**BOROUGH OF HIGHLANDS
LAND USE BOARD MEETING**
151 Navesink Ave. - Court Room
Thursday, May 09, 2024 at 7:00 PM

3. LUB2022-06: Martin, 15 Barberie Ave, B77 L15 - Extension Request
4. LUB2022-10: Home & Land - 14 & 32 North Peak, B35 Ls 8 & 9

**MINOR SUBDIVISION OF
LOTS 8, 9 ~ BLOCK 35**
32 & 14 North Peak Street
Borough of Highlands
Monmouth County, New Jersey

DATE: 04-05-2024 SCALE: 1"=20' DRAWN: AJC CHECKED: FF SHEET: 5 OF 8 JOB: PR-0290

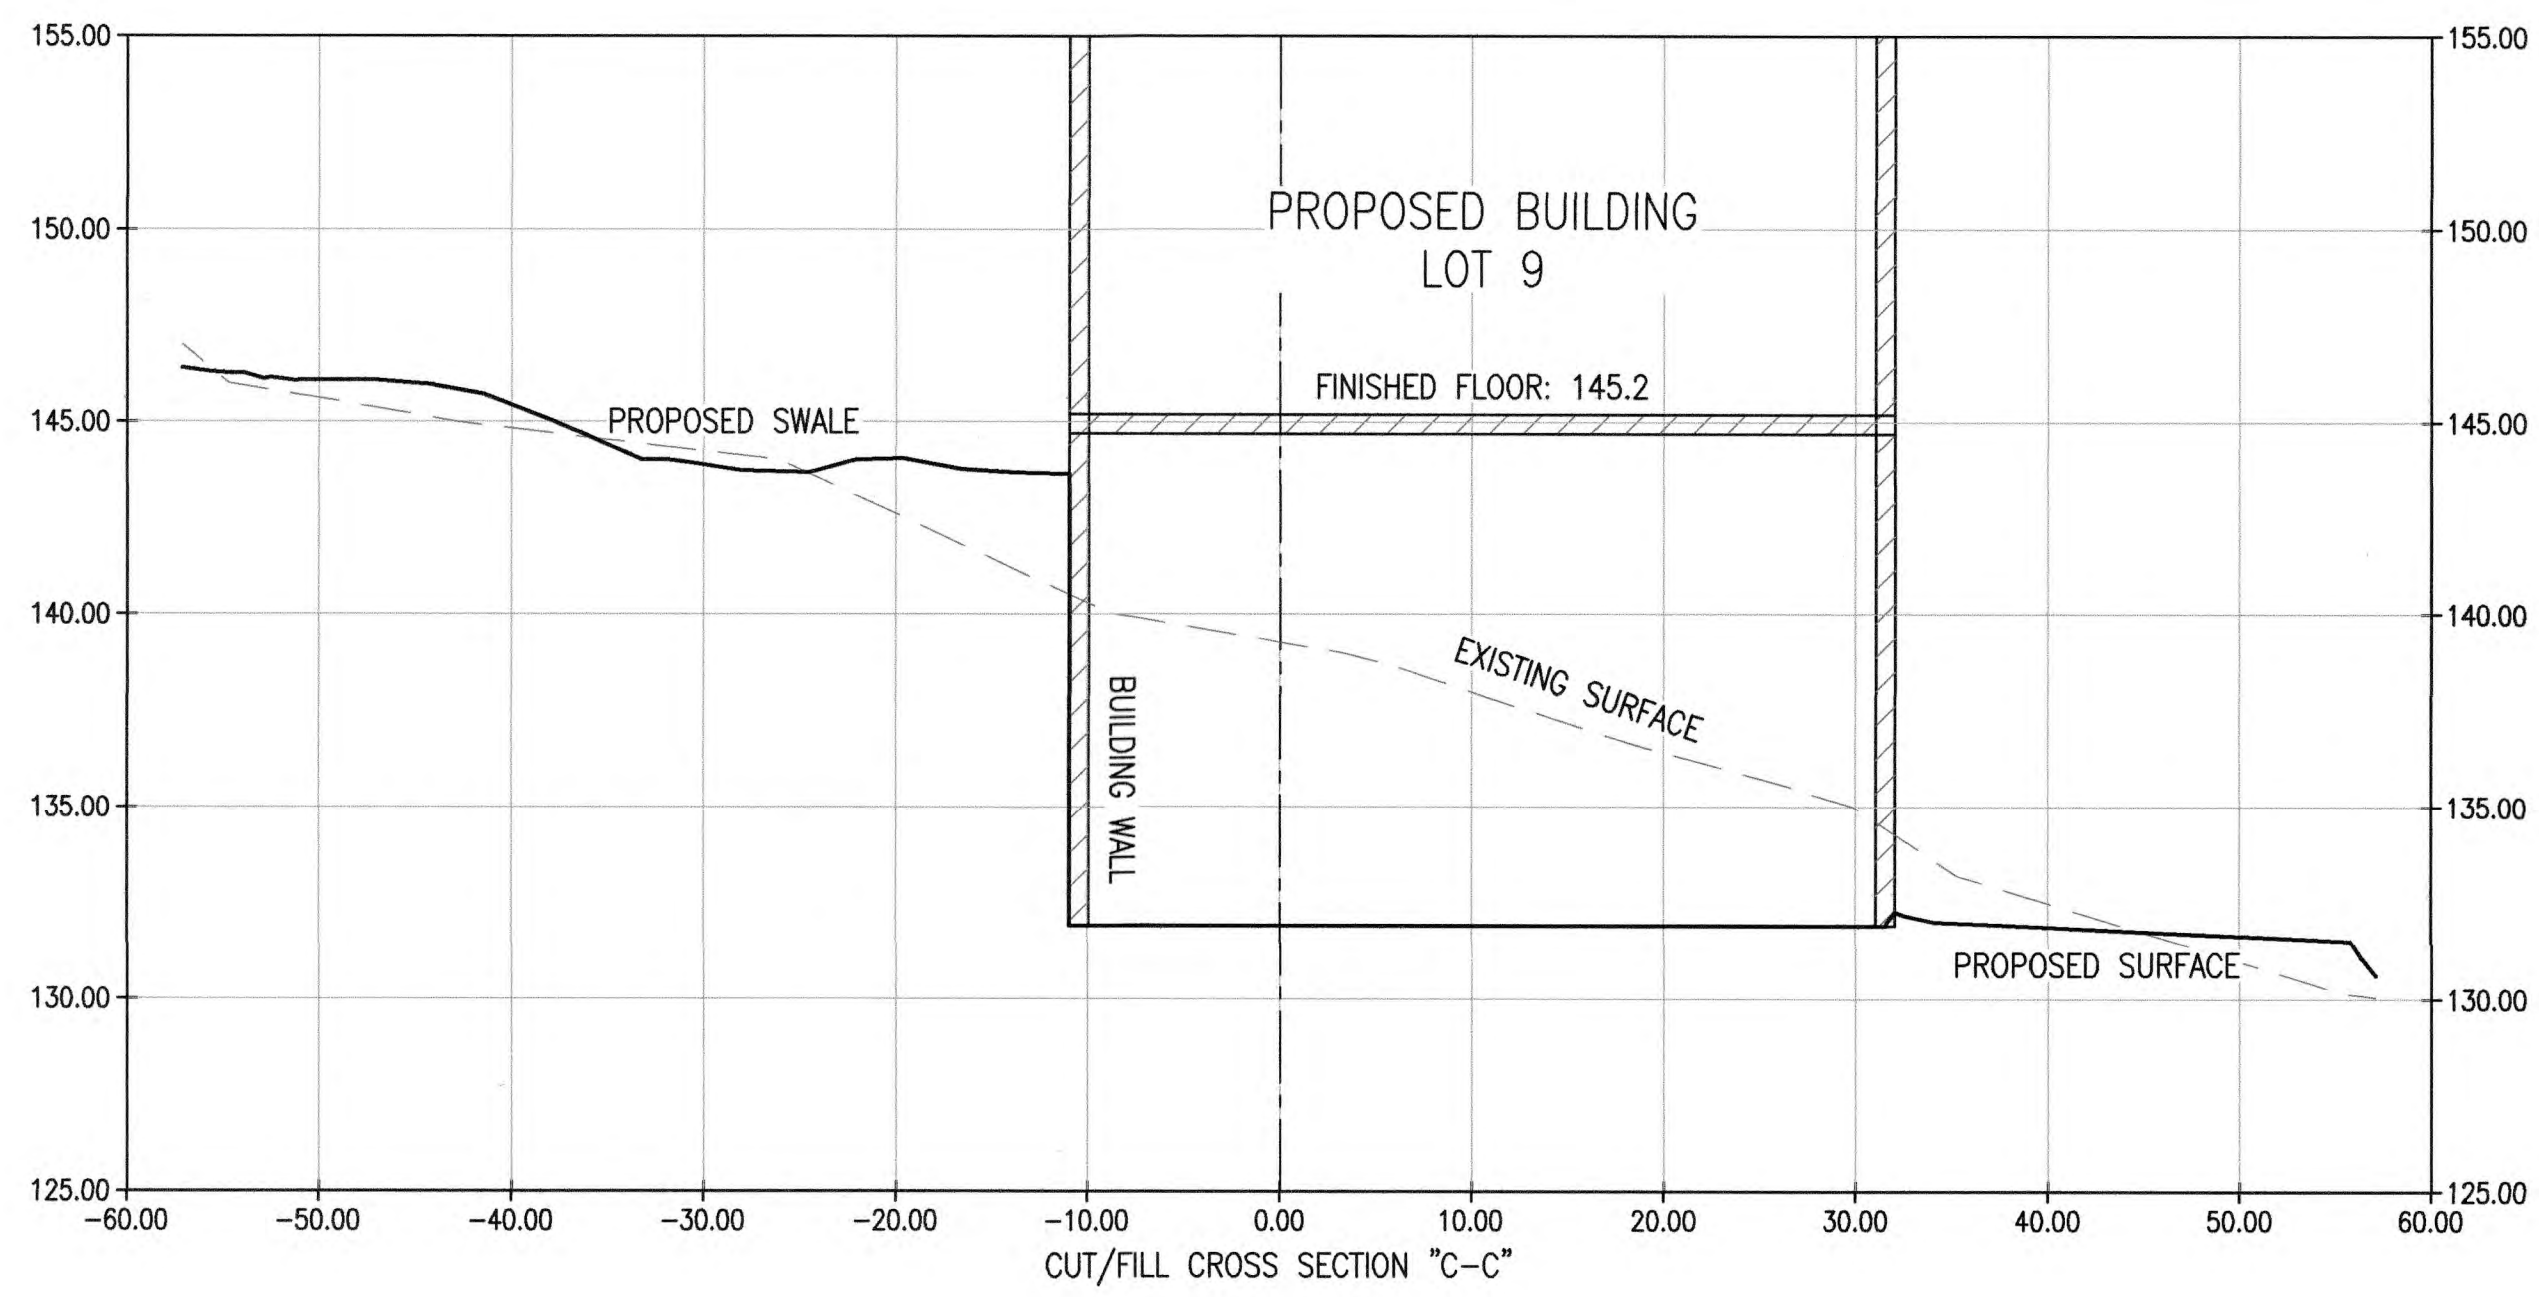
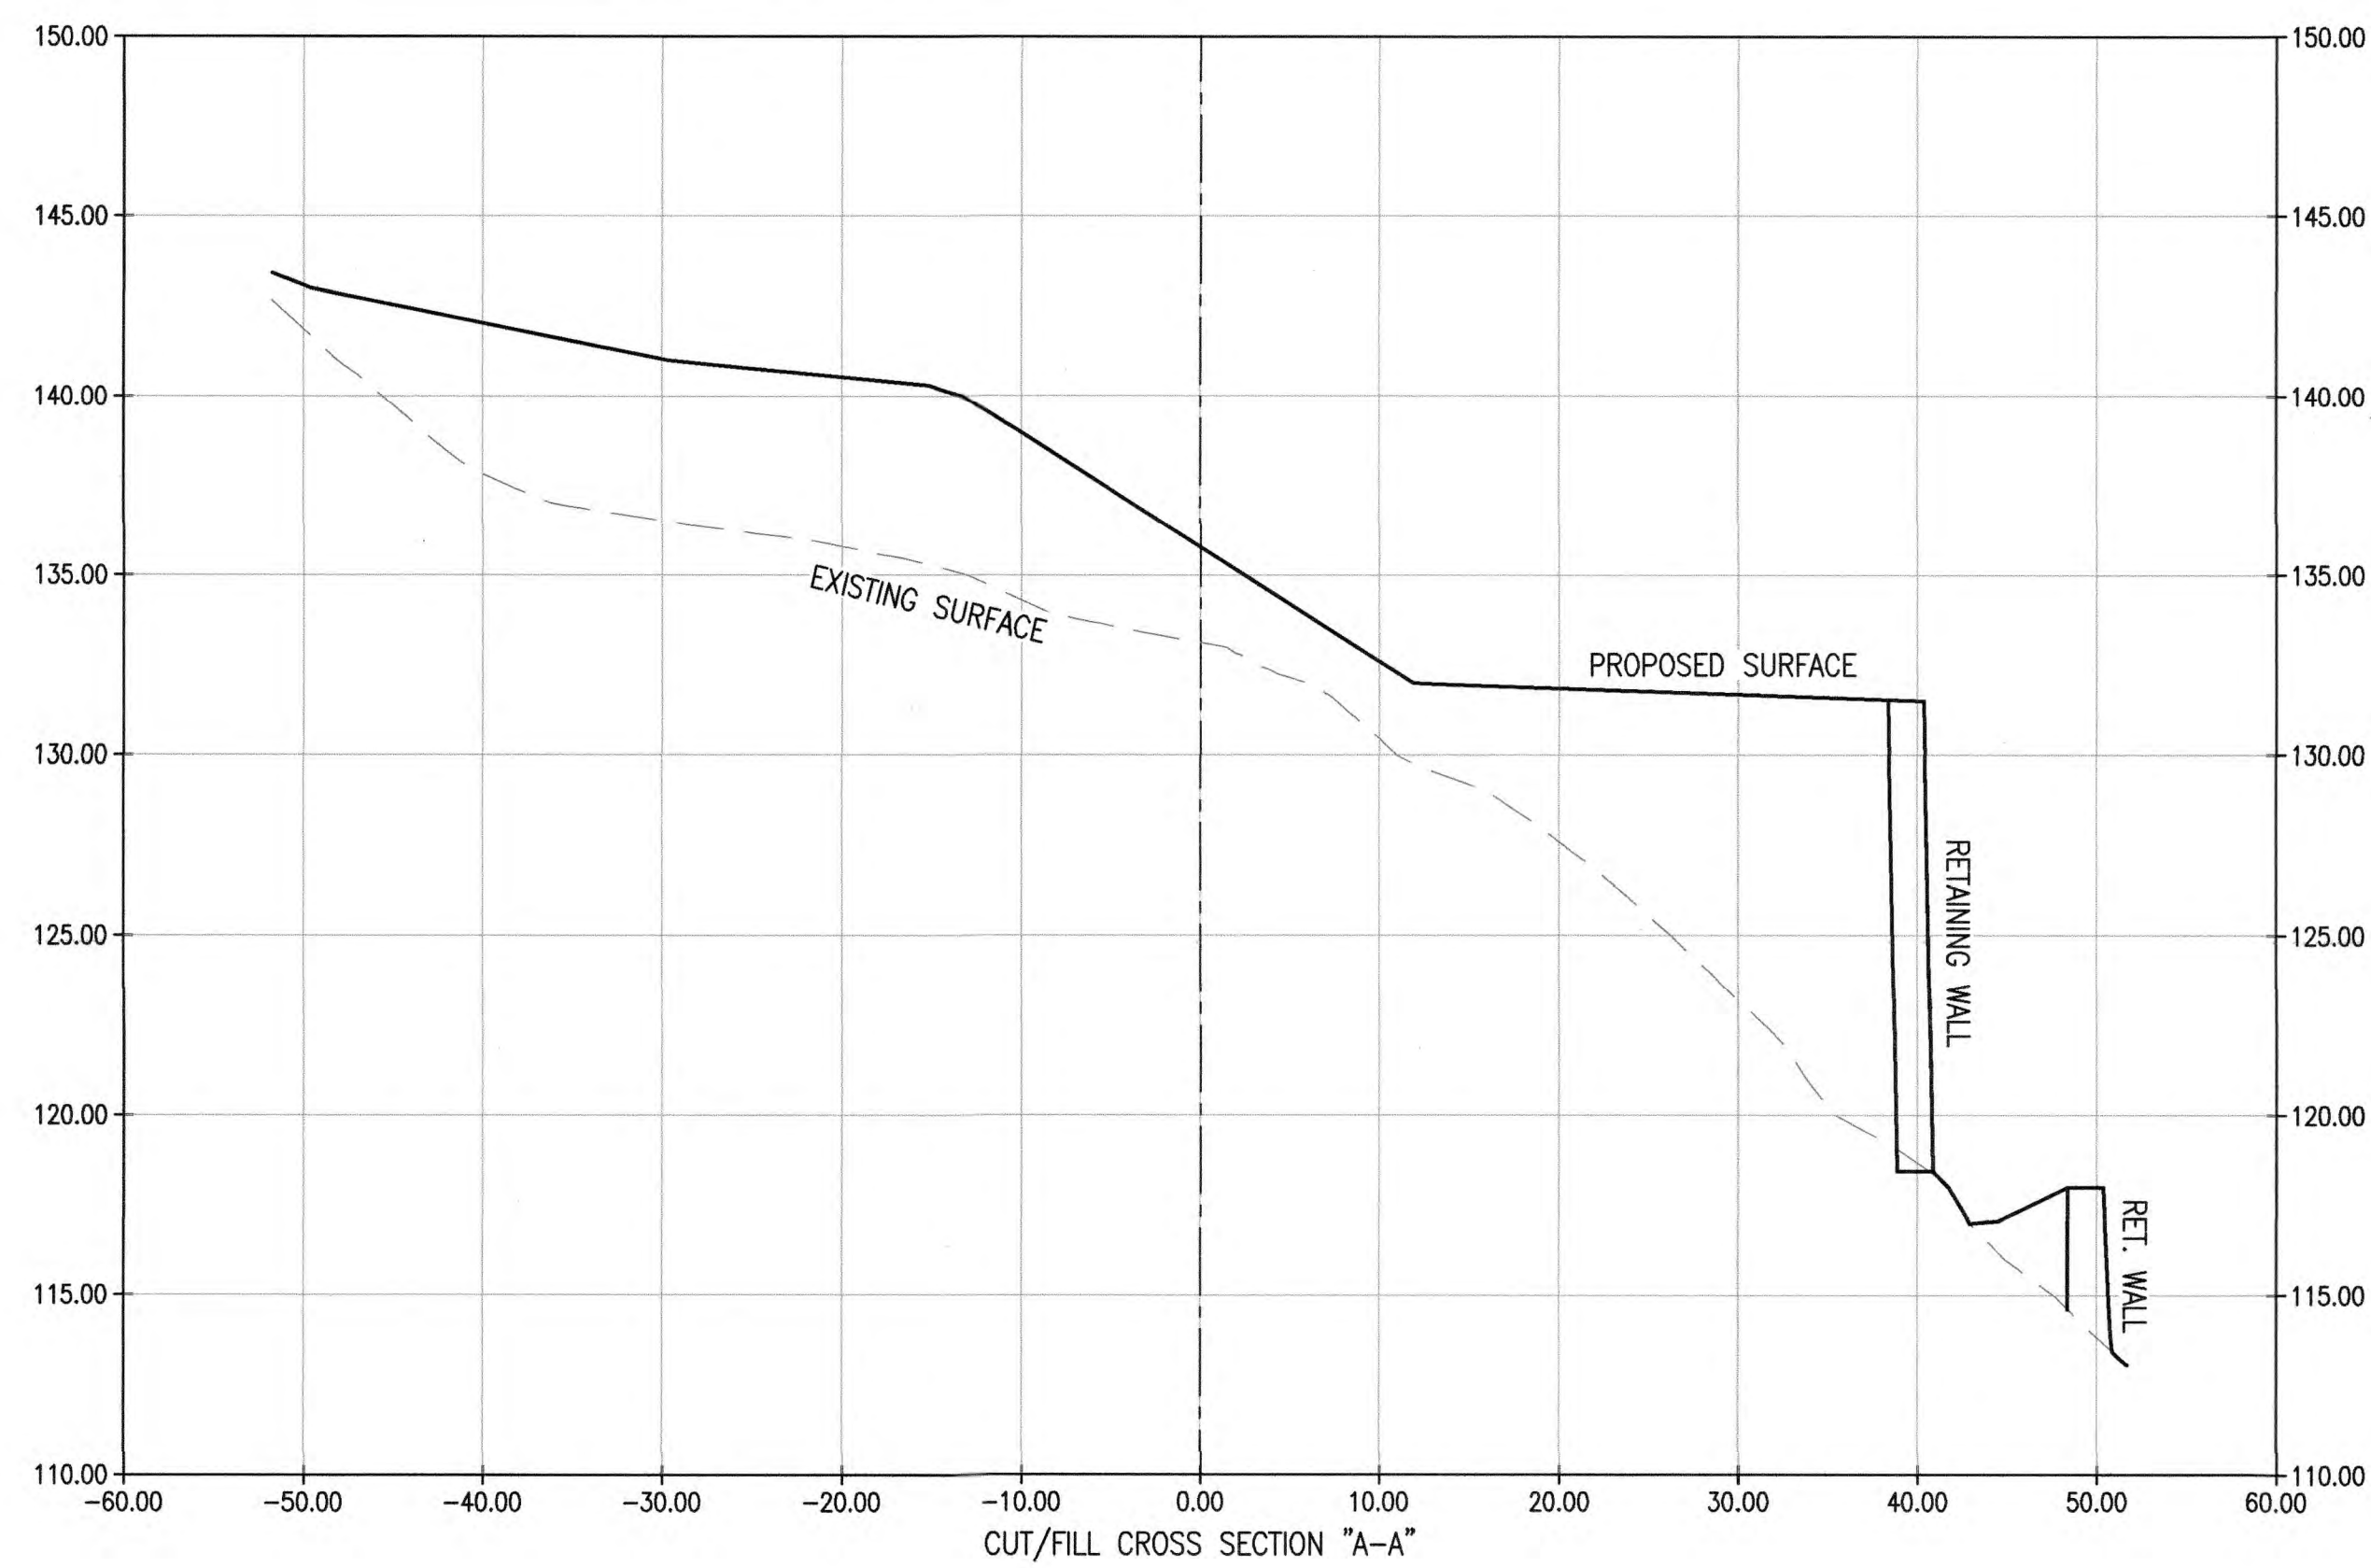
13. Cross sections C-C and D-D on Plan Sheet 6 of 8, Cut/Fill Cross Sections and Calculations should include both retaining walls (rear yard and North Peak Street). All cross sections are to show property lines so that a clear evaluation may be made of the impact of the walls.
